Source: TSG CN WG1
Title: CRs to R99 on Work Item GPRS/UMTS interworking
Agenda item: 7.16
Document for: APPROVAL

This document contains 15 CRs on R99 Work Item "GPRS/UMTS interworking", that have been agreed by TSG CN WG1 and are forwarded to TSG CN Plenary meeting #11 for approval.

Figure 10.5.2/TS 24.008 Ciphering Key Sequence Number information element

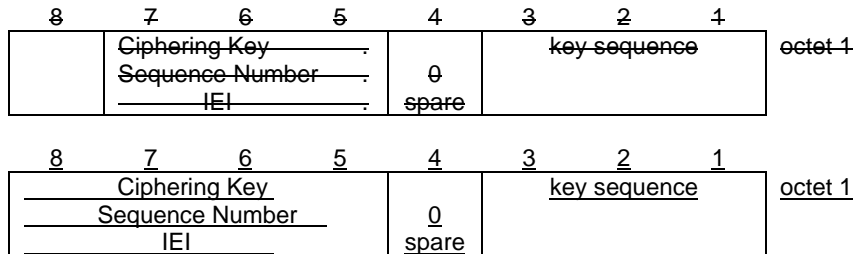
Reason for change:	⌘ The IEI value "8" for CKSN IE should be corrected to "8-" in table 9.4.9 in chapter 9.4.4, as only the four most significant bits in the octet 1 of the ciphering key sequence number IE defines the IEI value. Bit 8 in figure 10.5.2 shall also be used for the CKSN IEI in order to make the value "8-" a possible value for this IEI.		
Summary of change:	⌘ Correction of the IEI value of the GPRS CKSN IE in the Authentication and Ciphering Request message.		
Consequences if not approved:	⌘

Figure 5.6/24.007: Protocol architecture of Non Access Stratum supporting CS/PS mode of operation MSs, MS-side

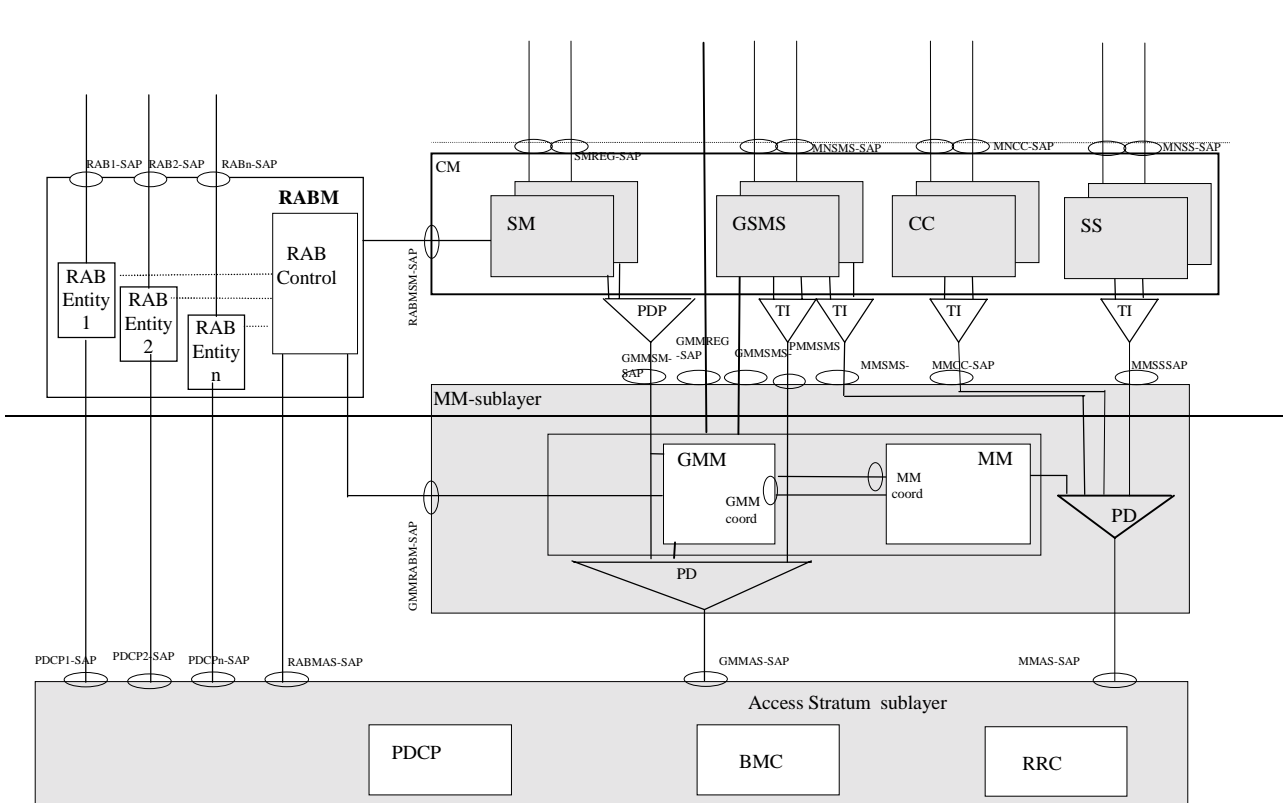
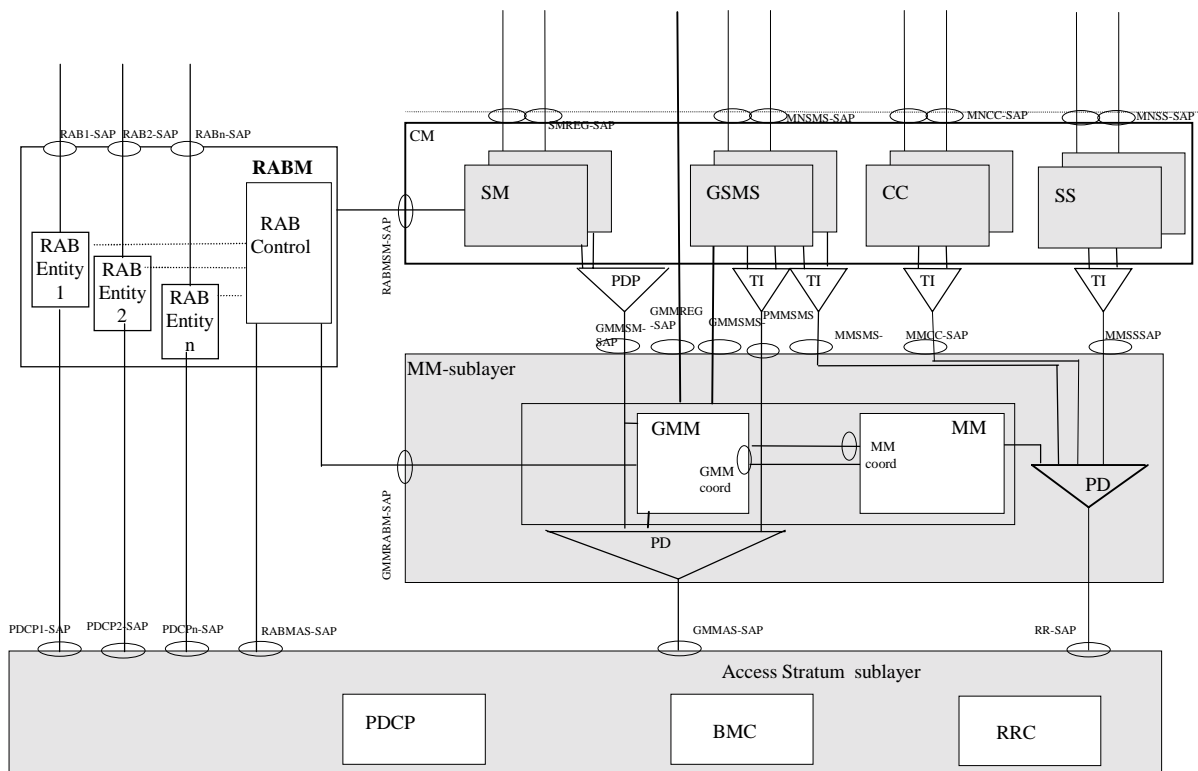
Reason for change:	⌘ In the description sections the SAP between MM and AS is called RR-SAP while in fig 5.6 the SAP is wrongly called MMAS-SAP.		
Summary of change:	⌘ The SAP in fig 5.6 has been renamed correctly		
Consequences if not approved:	⌘ Fig. 5.6 is inconsistent.

Figure 44 (sheet 8 of 54): Handover control procedure in 3G_MSC-B

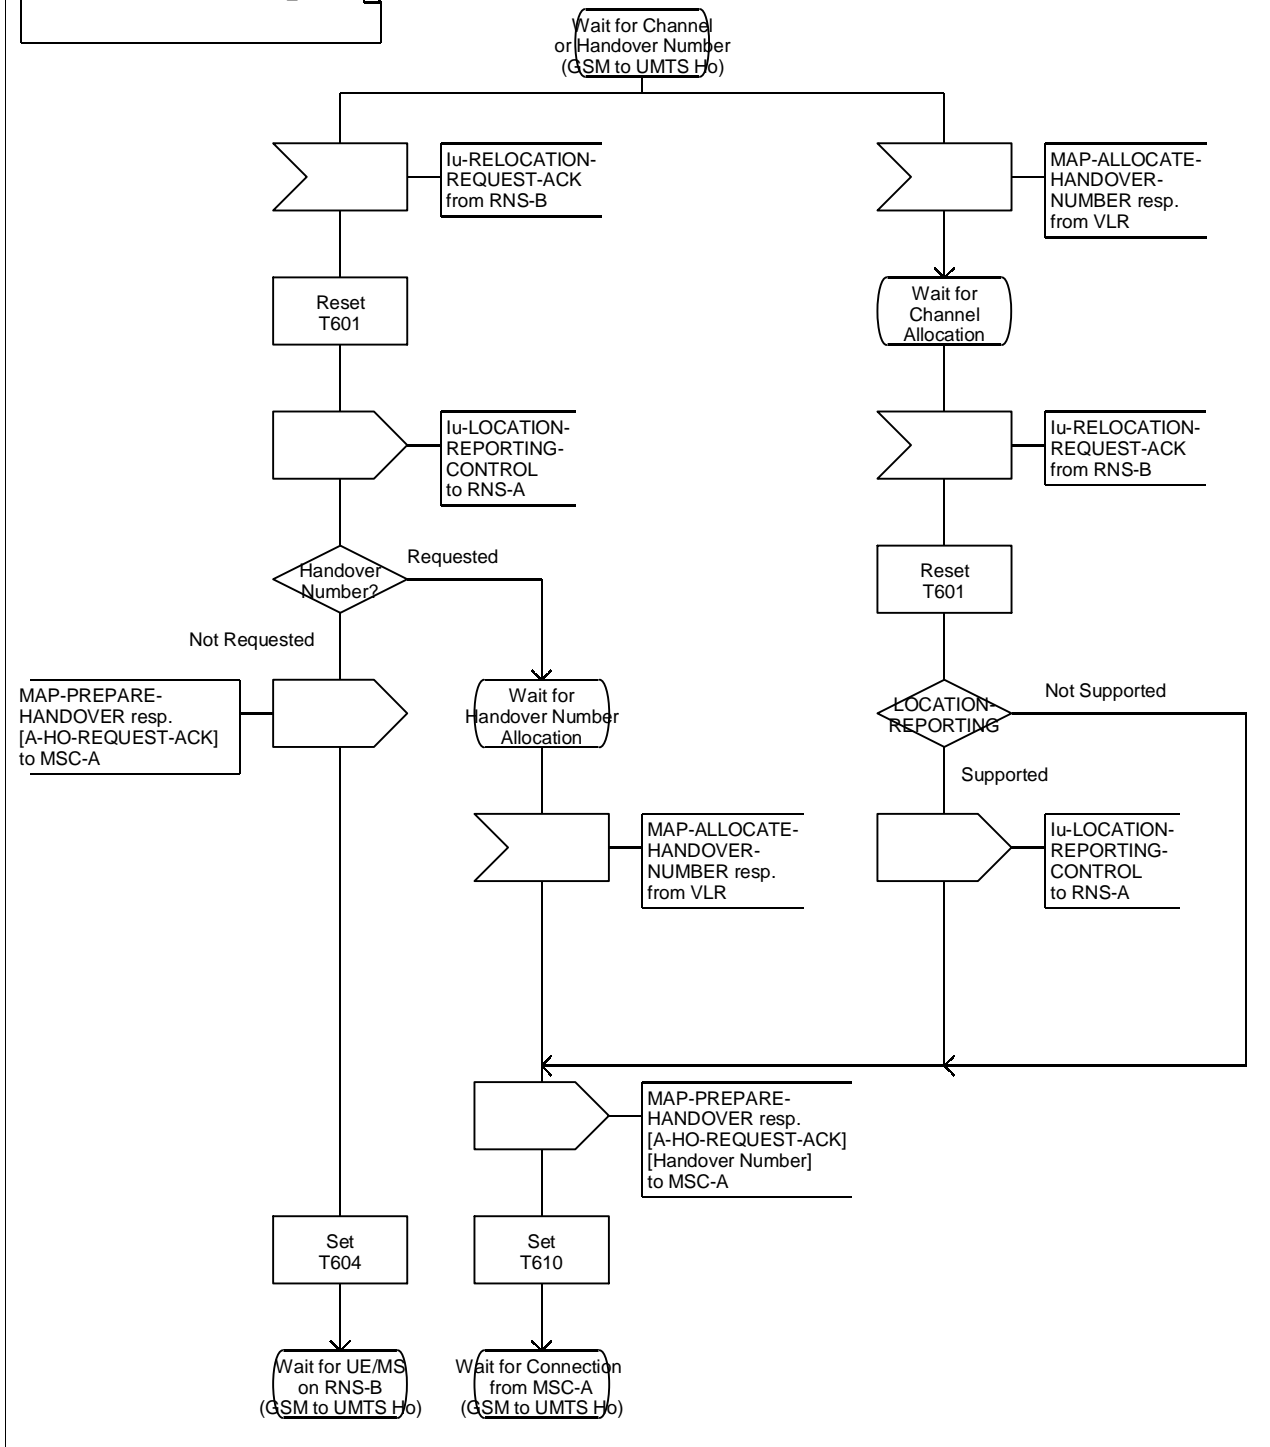
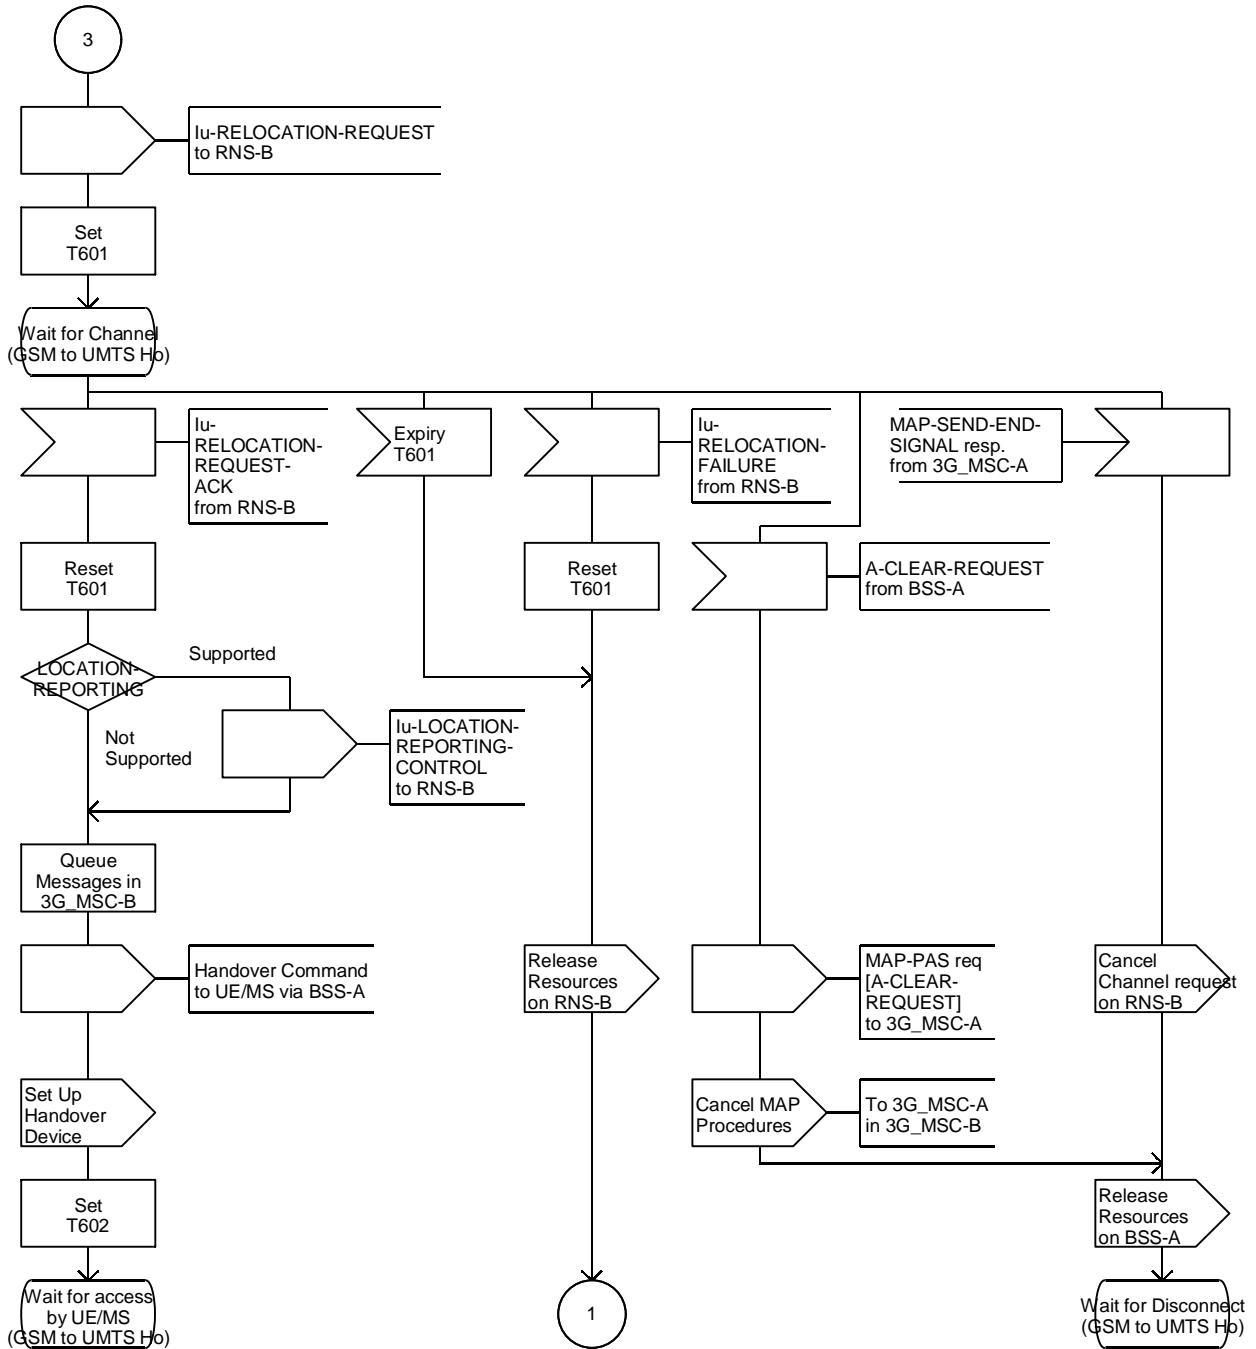
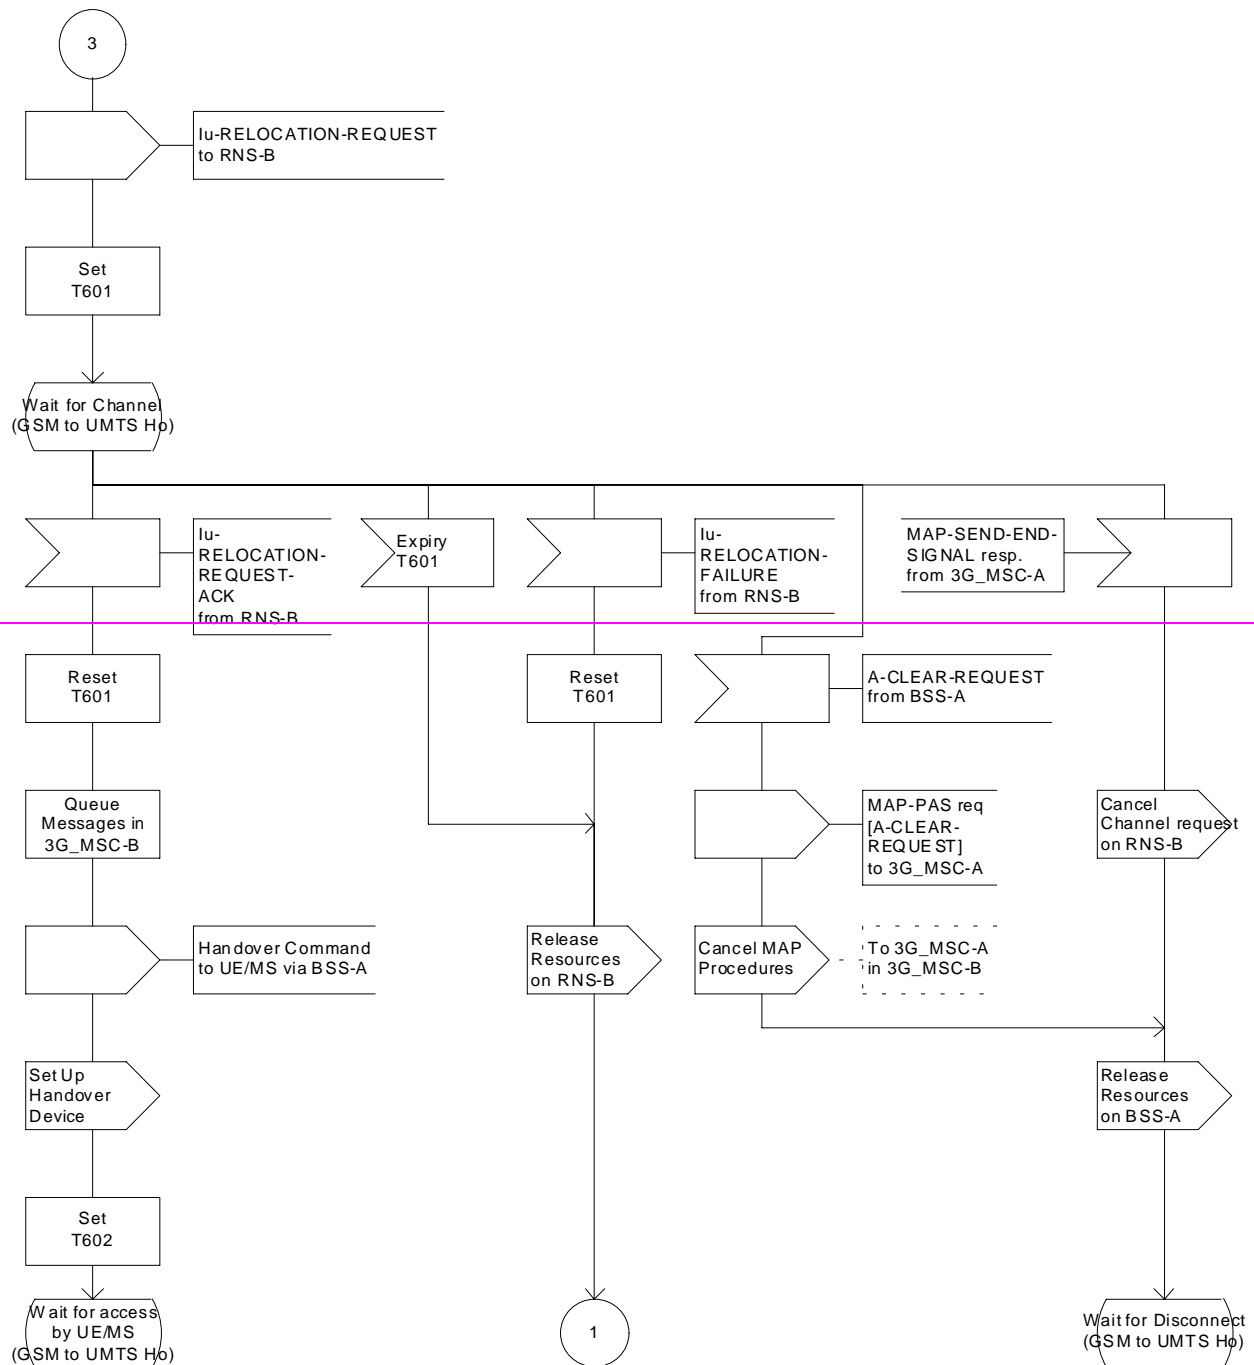
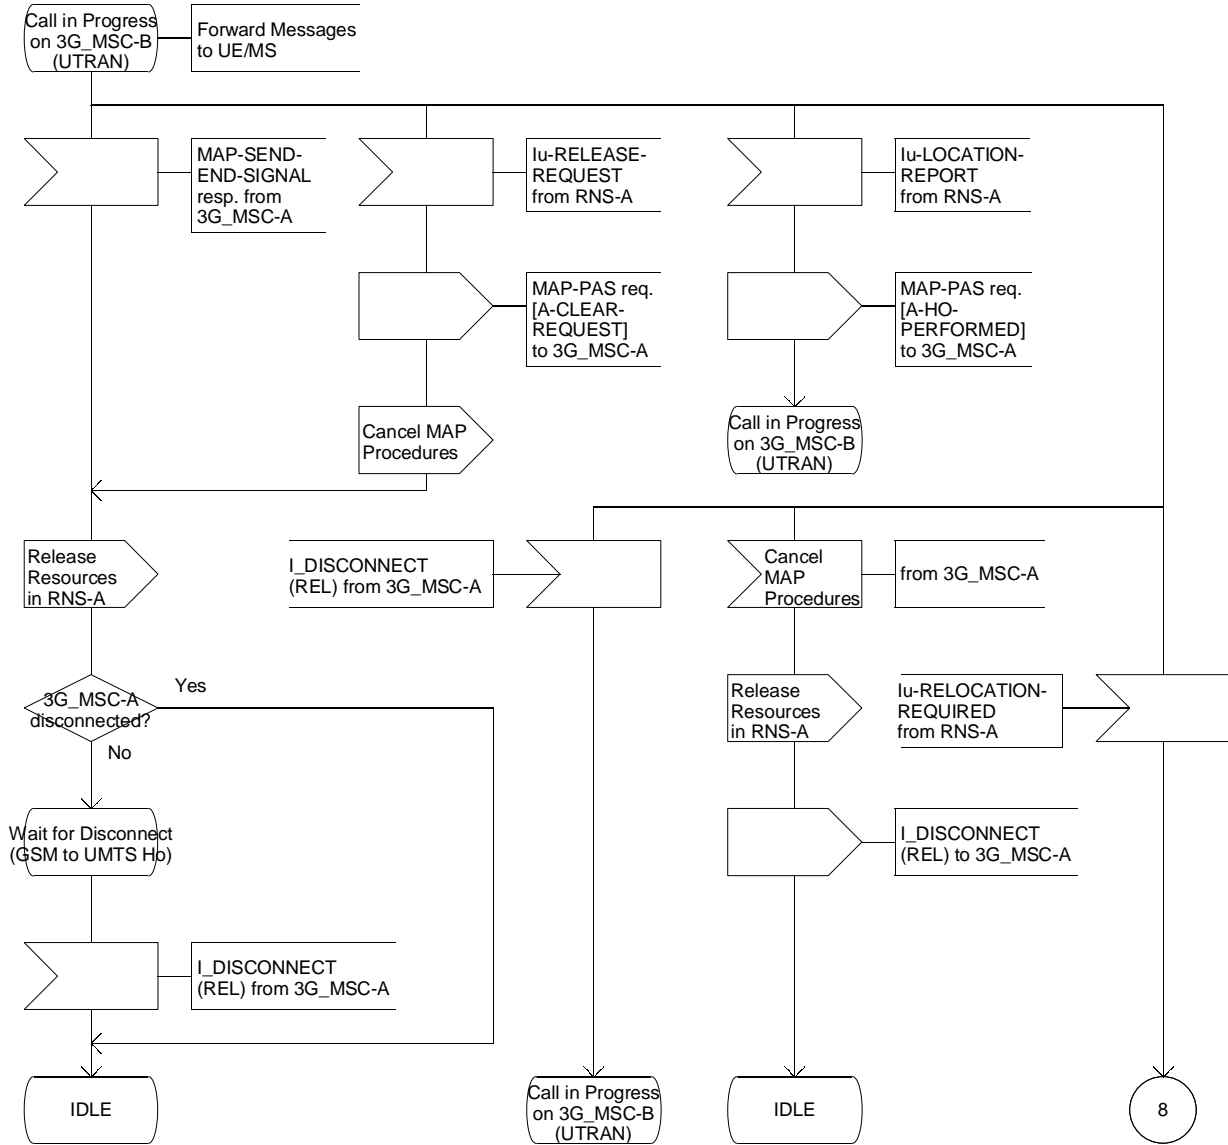
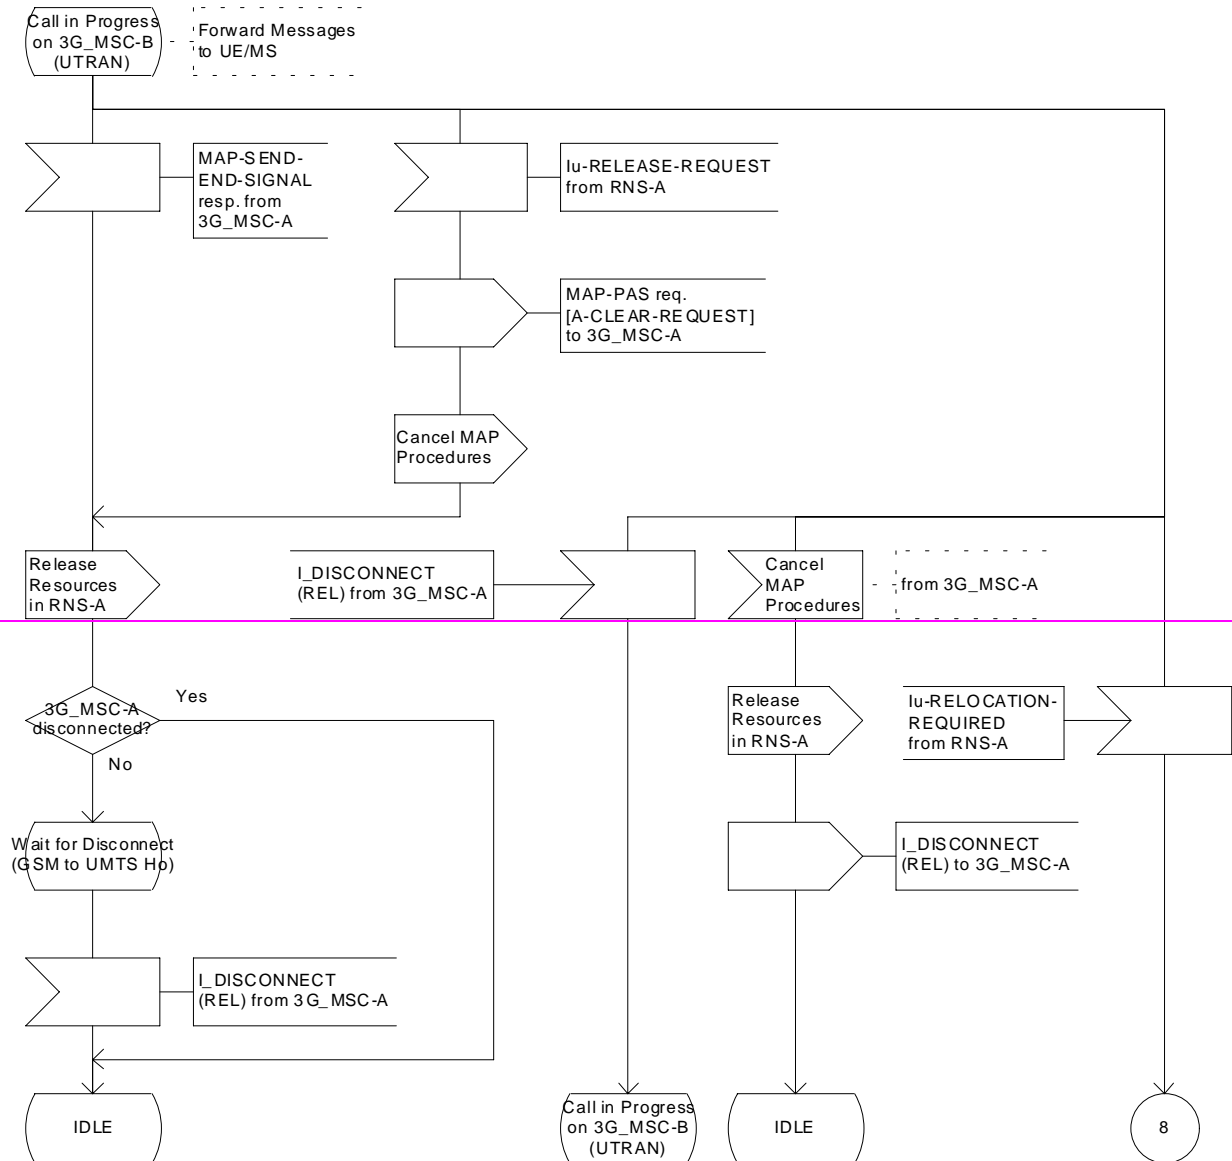
Reason for change:	⌘ 3G_MSC-B or 3G_MSC-B' should always initiate the Location Reporting Control procedure towards the target RNC since the MAP-E interface doesn't support initiation of the Location Reporting Control procedure from MSC-A in case of an inter-MSC GSM to UMTS handover. If no reporting control is required from the target RNC, after an inter-MSC GSM to UMTS handover, neither legal interception nor location based services running in the anchor MSC will work, due to that the RNC does not inform of location changes.
Summary of change:	⌘ Location Reporting Control procedure is introduced in GSM to UMTS HO.
Consequences if not approved:	⌘ Neither Legal Interception nor Location based services will work properly after the GSM to UMTS HO.

Clauses affected:	⌘ Fig. 44 (sheet 2, 8 and 24 of 54)		
Other specs affected:	<input type="checkbox"/> Other core specifications <input type="checkbox"/> Test specifications <input type="checkbox"/> O&M Specifications	⌘ 29.010 CR008	
Other comments:	⌘
